AGENDA  
PEACH BOTTOM ATOMIC POWER STATION, UNITS 2 AND 3  
LICENSE RENEWAL APPLICATION  
MONDAY, OCTOBER 22, 2001

# Peach Bottom Atomic Power Station

License Renewal Application

Scoping and Screening

**Figure 2.1-1 - Scoping and Screening Process Overview**

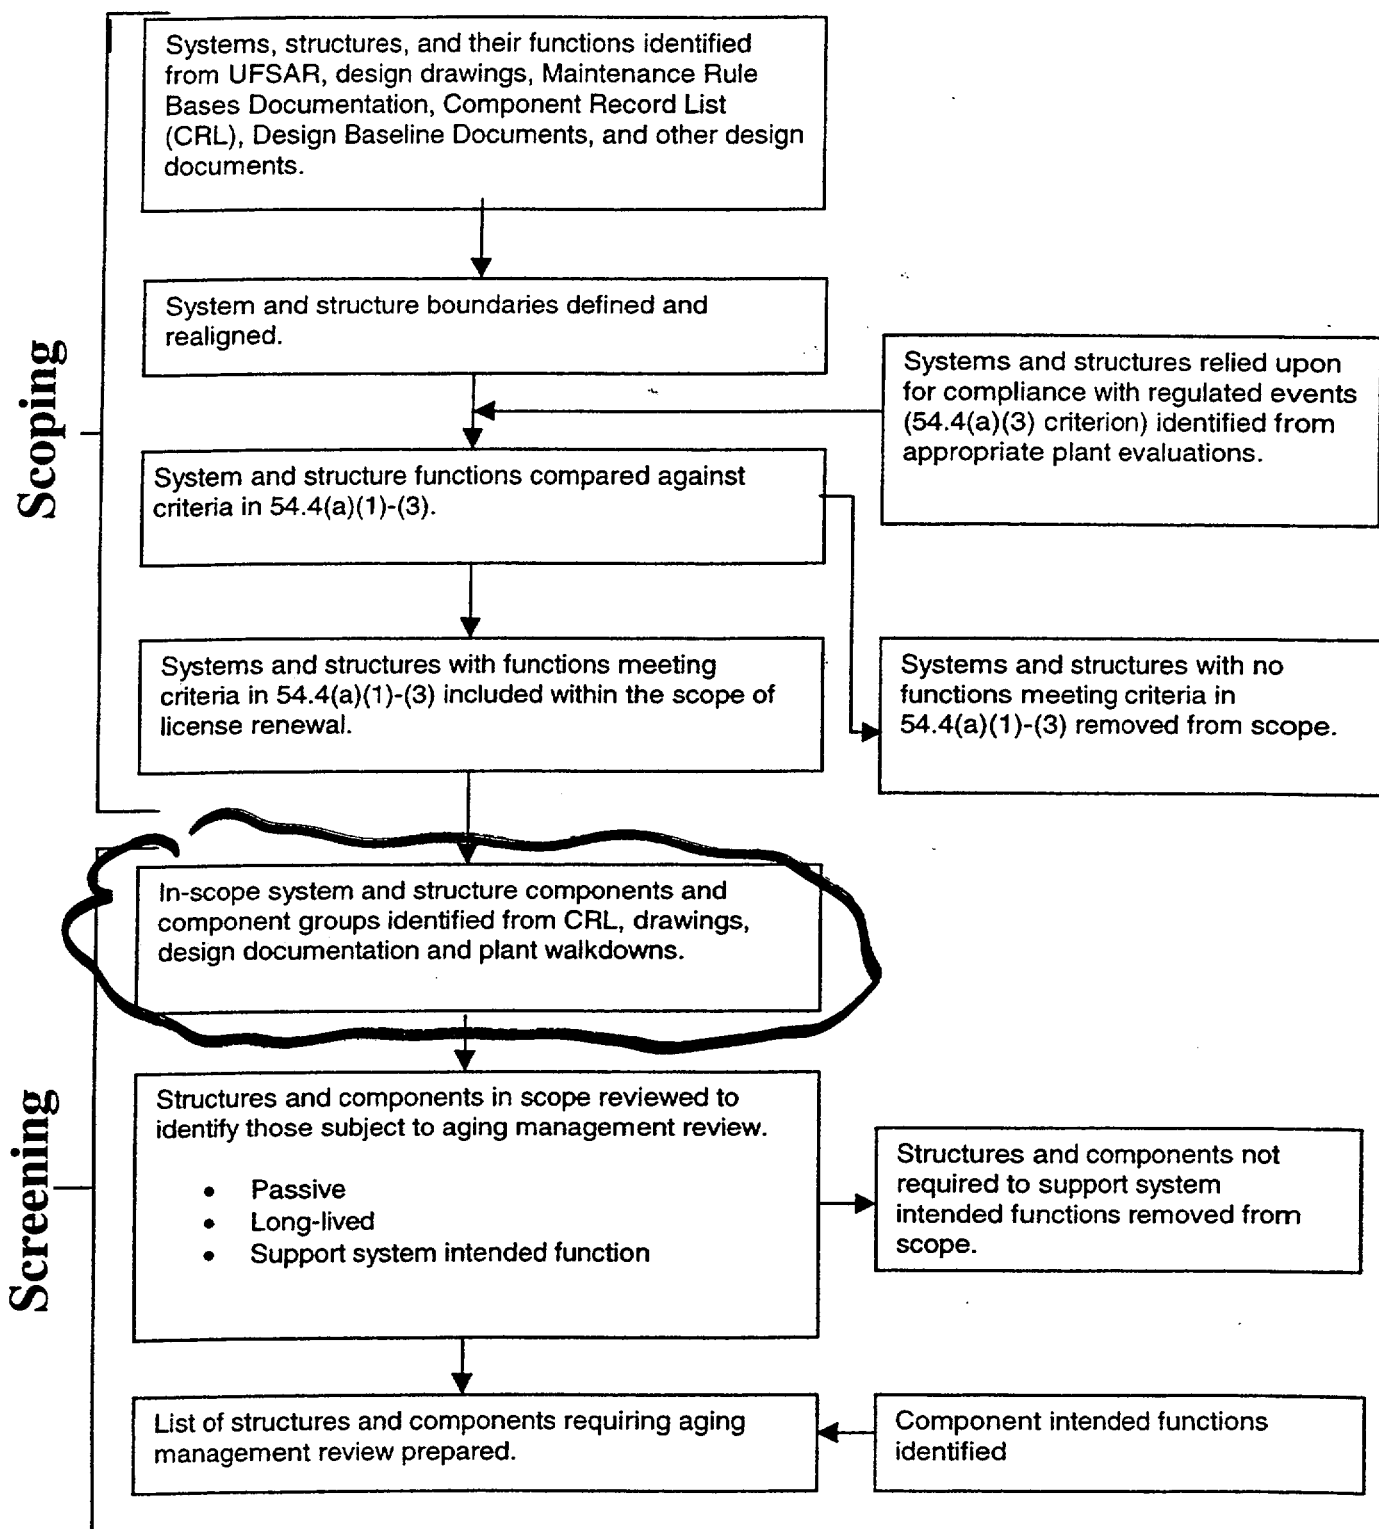
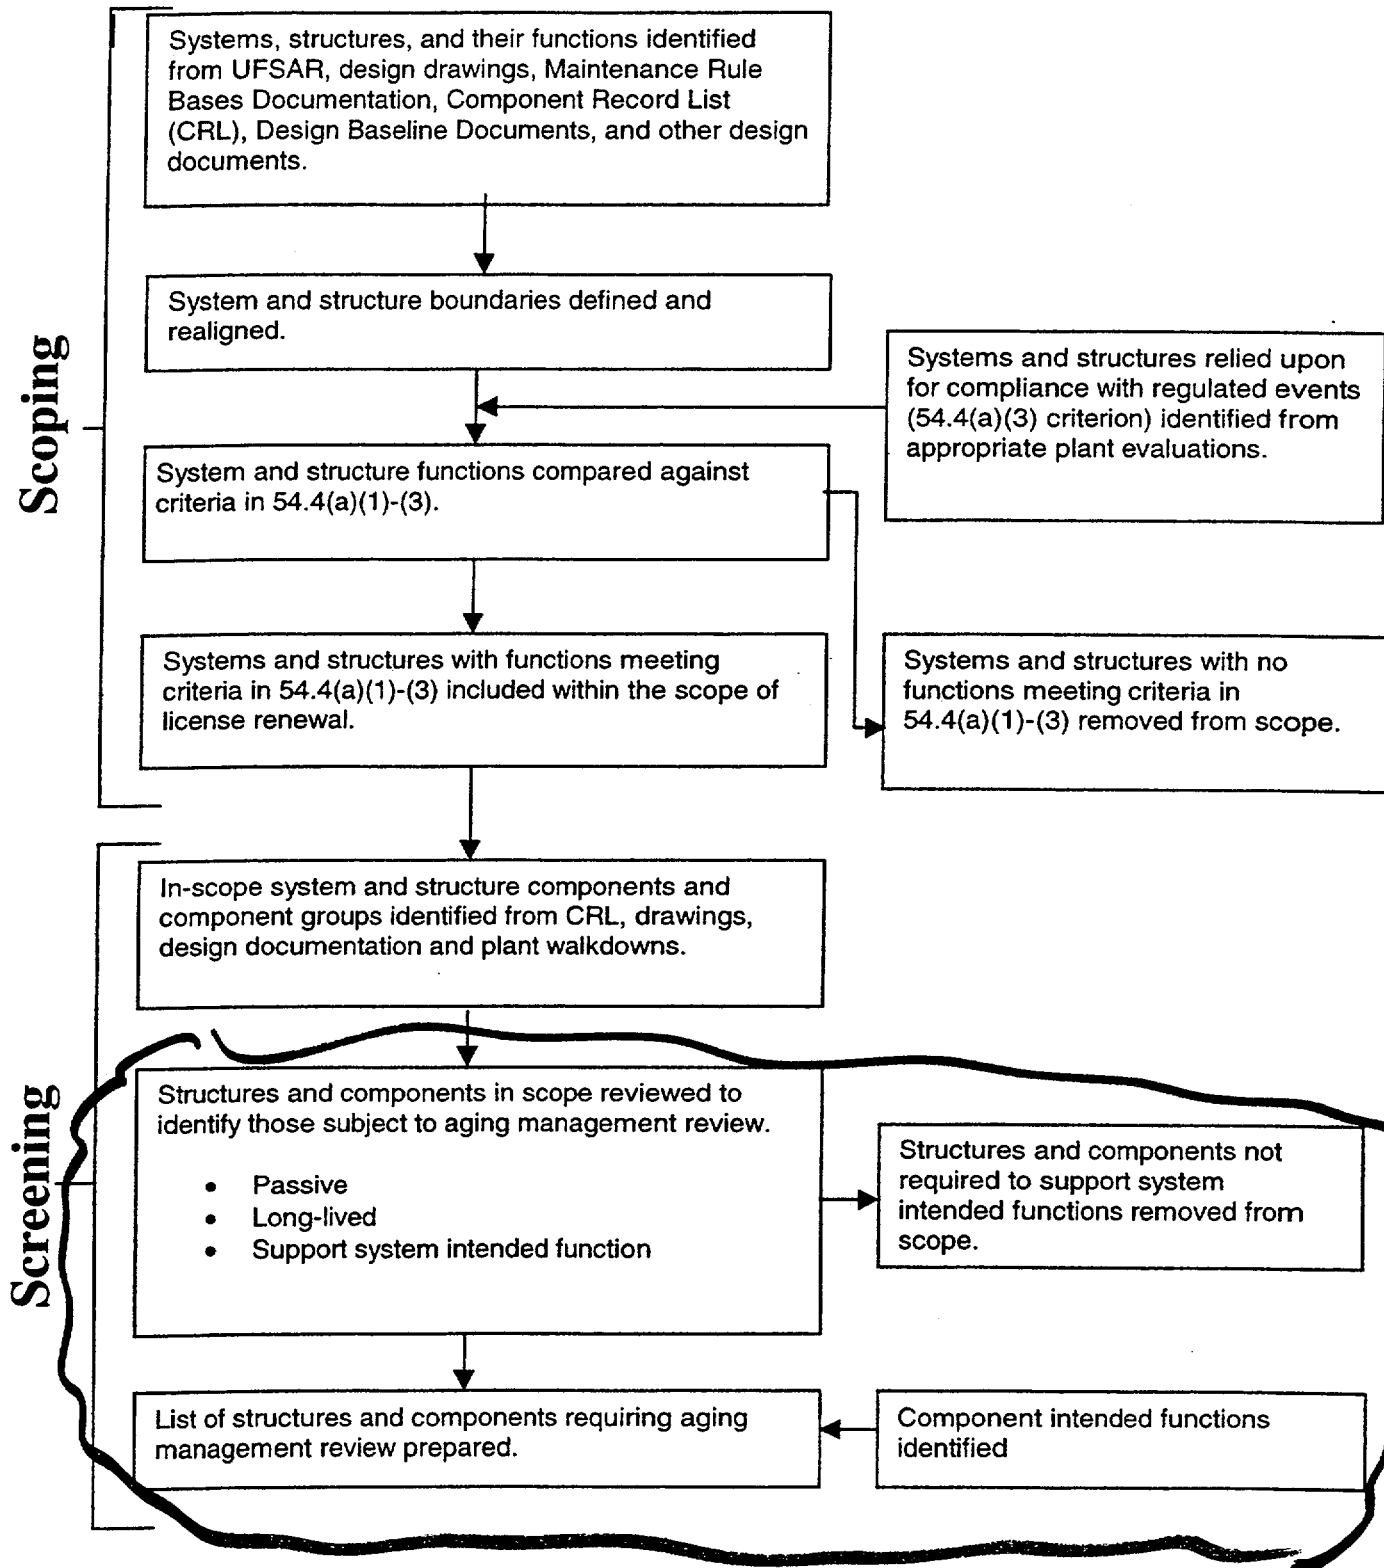
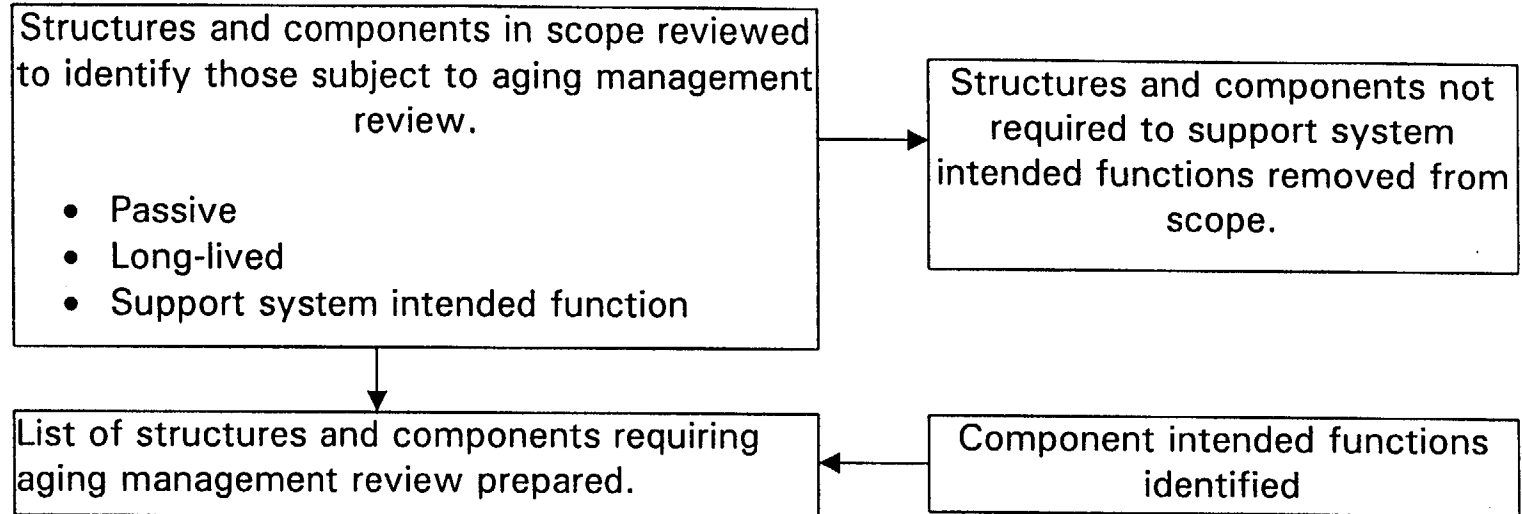
1	Introduction : Define the issues and expected outcome of the meeting.	NRC	9:00am
2	Clarify the scoping and screening process as shown in figure 2.1-1 of the PBLRA, as discussed at the meeting on 9/24/01, and explain how Exelon concluded that this process meets the requirements of 10 CFR 54.4 with respect to the following: <ul style="list-style-type: none"> <li>• System intended functions.</li> <li>• Explain the system realignment process and the rational for its use.</li> <li>• Determination of system/structure boundaries.</li> <li>• How the systems, structures and components reflected in the Peach Bottom current licensing basis [as defined by §54.3(a)] are captured in a consistent manner in the scoping process.</li> <li>• Explain the differences between the Component Record List and the UFSAR and how they are treated by the scoping process and reflected in the LRA.</li> </ul>	Exelon	9:15am

-Break-		10:45am
3	Discussion of NRC examples of apparent scoping inconsistencies and LRA clarity that could hamper the transparency of the review process: <ul style="list-style-type: none"> <li>• Reactor Water Cleanup (RWCU) System example is not in-scope (Fig 2.1-1 vs §54.4) but SCs of RWCU are in-scope per §54.21.</li> <li>• Given that system boundaries have been realigned for the PB LRA, how can the staff efficiently determine that all SCs are included in the Component Groups defined by the PBLRA?</li> </ul>	NRC	11:00am
	-Lunch-		12:00pm
4	Exelon to provide explanation for the specific examples in item 3 as to how the scoping and screening process was performed to ensure that SCs that need to be in scope of license renewal are captured in a consistent manner, in accordance with Part 54.	Exelon	1:00pm

- A comprehensive list of systems and structures to be evaluated for license renewal scoping was produced from the above documentation sources (LRA page 2-2, Section 2.1.2.1, first paragraph). These information sources are consistent with NUREG-1800 Standard Review Plan for License Renewal Table 2.1-1, and also Table 3.1-1 of NEI 95-10 revision 3, endorsed by Regulatory Guide 1.188:

- Component listings were downloaded from the CRL for each system.
- Component listings were used to mark-up P&ID drawings to establish in-scope system boundaries (LRA page 2-5).
- Some non-safety related systems at PBAPS include safety related components. For example, isolation valves in the makeup water fill connection to the safety related High Pressure Service Water (HPSW) system are safety related because they are part of the HPSW boundary. The makeup water connection is from the Water Treatment System, which is not safety related, but these individual isolation valves are safety related. Other examples are described on page 2-5 of the LRA, under the sub-heading of System Boundary Realignment.

- This is a general overview of the process of addressing the license renewal scoping criteria, which is described in detail in LRA pages 2-6 through 2-10.
- For systems, evaluation against criteria 54.4(a)(1) and (2) is based on Maintenance Rule program scoping documentation (LRA page 2-6 and 2-7).
- For structures, evaluation against criteria 54.4(a)(1) and (2) is based on review of UFSAR seismic classification (LRA pages 2-6 through 2-8).
- For systems and structures, evaluation against criteria 54.4(a)(3) is based on review of appropriate plant evaluations for the regulated events (page 2-9 and 2-10). License renewal position papers were prepared to identify specific systems credited for 10 CRF 50.48 (Fire Protection) and for 10 CFR 50.63 (Station Blackout).
- ATWS systems determined from CRL ATWS data field.

- Screening Methodology described in LRA Section 2.1.3, page 2-12 through 2-14.
- Final listing of in-scope components identified from previously downloaded component listings.
- Components entered into a License Renewal Database.
- Additional components not included in the CRL were identified and added to the database.

- Screening Methodology described in LRA Section 2.1.3, page 2-12 through 2-14.
- Component active versus passive determinations made in accordance with 10 CFR 54.21(a)(1)(i) and the guidance of NEI 95-10.
- Long-lived components identified in accordance with 10 CFR 54.21(a)(1)(ii) and the guidance of NEI 95-10.
- During this detailed component level review, any additional components identified that are not required to support a system intended function are removed from the scope of license renewal. Component listings (the license renewal database) and boundary drawings were updated as required.
- Intended functions identified for the structures and components requiring aging management review.

- Based on the above discussions regarding the scoping and screening process as outlined in Fig. 2.1- 1 and explained in the LRA sections 2.1.2 and 2.1.3, including the discussion on realignment, Exelon concluded that this process met the requirements of 10 CFR 54.4.
- Systems and structures with intended functions that need to be in the scope of license renewal were included in the application.
- Exelon hopes this presentation helps NRC understand how this process fulfills the requirements of 10 CFR 54.4.
